# Disability Access Report

**Stage:** Section 4.55

**Project:** Opal St Ives Botanica  
S221104 - New 210 Bed Residential Care Facility at Opal St  
Ives

Enware IFO toilet - Screenshot from the enware.com.au

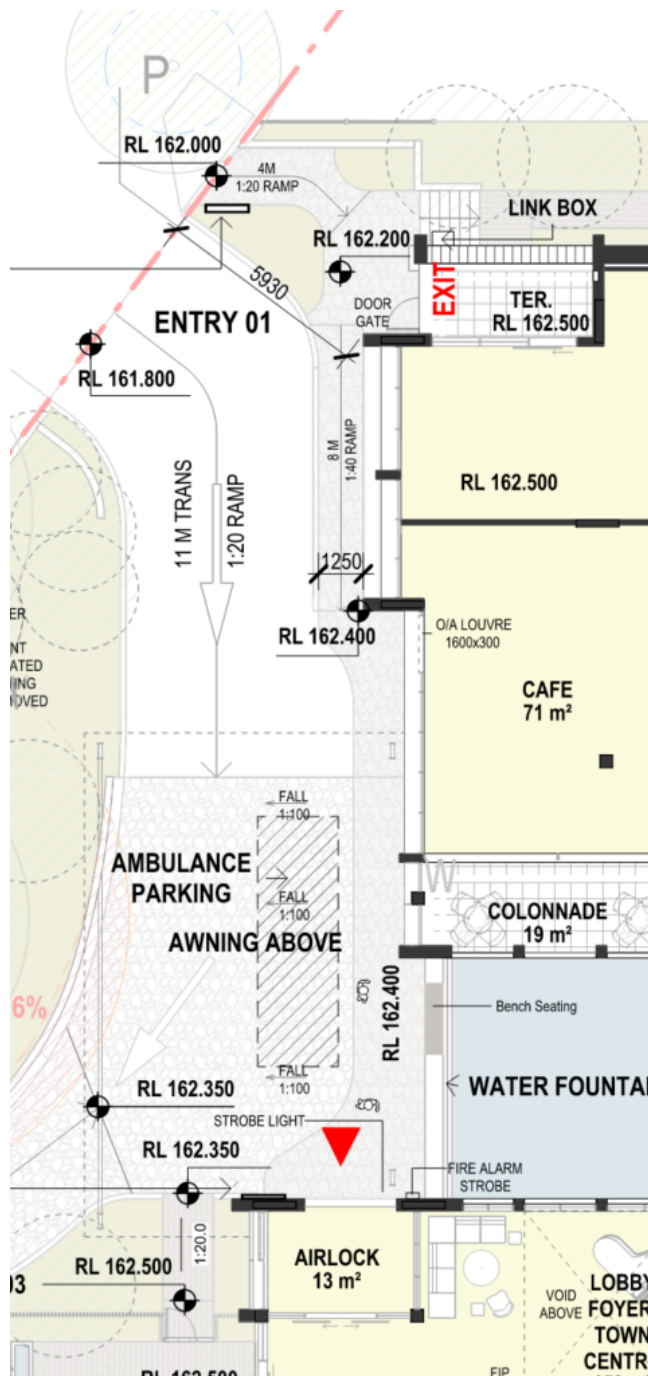
The sanitary compartment ensuites within the sole occupancy units have been designed to meet the performance requirements of the BCA. Which means the SOU ensuites fixtures and fittings do not meet the design requirements of AS1428.1 (2021). The toilet will be installed more than 450mm from the side wall, with no wall mounted grabrails.

The ensuites have all been designed to assist high-care residents who require significant assistance with daily health care and individual personal hygiene. It is proposed that the Enware IFO pans which have support arms will increase the residents ability for independent movement and aide the care team in assisting residents to sit and stand on both sides, which is the common need in aged care.

1. At time of the CC, determine whether a performance solution is required for not providing nine (9) accessible sole occupancy units in accordance with AS1428.1 (2021).
2. External and internal pathways comply with AS1428.1 (2021).
3. At time of CC common area doors and gates have compliance with AS1428.1 (2021) and D2D9 with respect to clear opening widths, luminance contrast on doors, door hardware, and door force is 20N including where a door closer is fitted.

Screenshot of corridor Level 01 from DWG DA2003 Issue 1

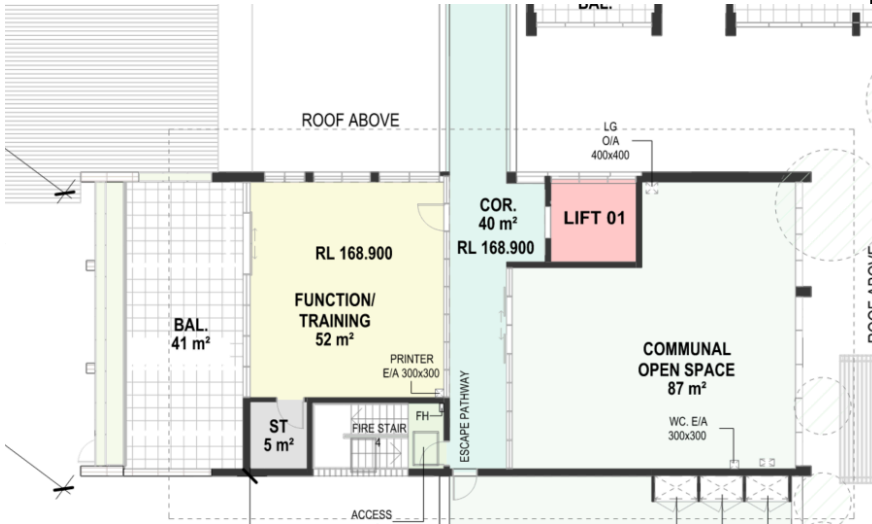
The corridor widths in all accessible areas of the building generally exceed 1540 mm. This design allows for turning spaces of at least 1540 mm x 2070 mm, in accordance with AS1428.1 (2021), to be provided along the majority of the corridors as indicated in the plans.

At time of Construction Certificate, ensure turning areas are provided at the end of all corridors, where there are rooms or facilities that are required to be accessible.

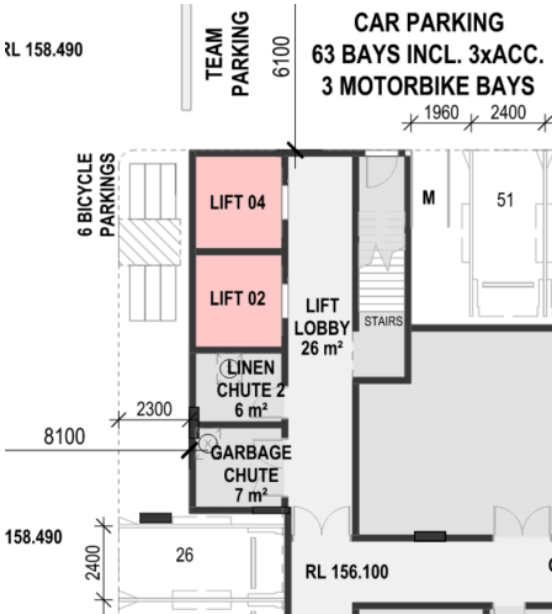
<p>Screenshot of a portion of Level 03 Dwg DA2007, Issue 1</p> <p><u>Recommended Action</u></p> <p>Further assessment prior to the Construction Certificate is required. Hearing augmentation to be in accordance with BCA Part D4D8 and AS1428.5. Ensure Signage to be in accordance with BCA Part D4D7 and Specification 15 Braille and tactile signs</p>
<p>D4D9 Tactile indicators</p>	<p>✓</p> <p>Provide detail at CC</p>	<p><b>Tactile indicators within Class 9c buildings</b></p> <p>Tactile indicators are not required within a Class 9c Residential Aged care building however where there are handrails on a stairway or ramp a raised dome button in accordance with AS/NZS 1428.4.1 is to be provided to warn people who are blind or have a vision impairment that they are approaching a stairway or ramp</p> <p><u>Recommended Action</u></p> <ul style="list-style-type: none"> <li>In detailed design drawings for CC, show a raised dome button in accordance with AS/NZS 1428.4.1 on stair or ramps handrails within the Class 9c building.</li> </ul> <p><b>Back of house and Car Park Ground floor</b></p> <p>Where there are stairs within the lower ground floor back of house and car park areas, tactiles indicators are required as per the BCA.</p>
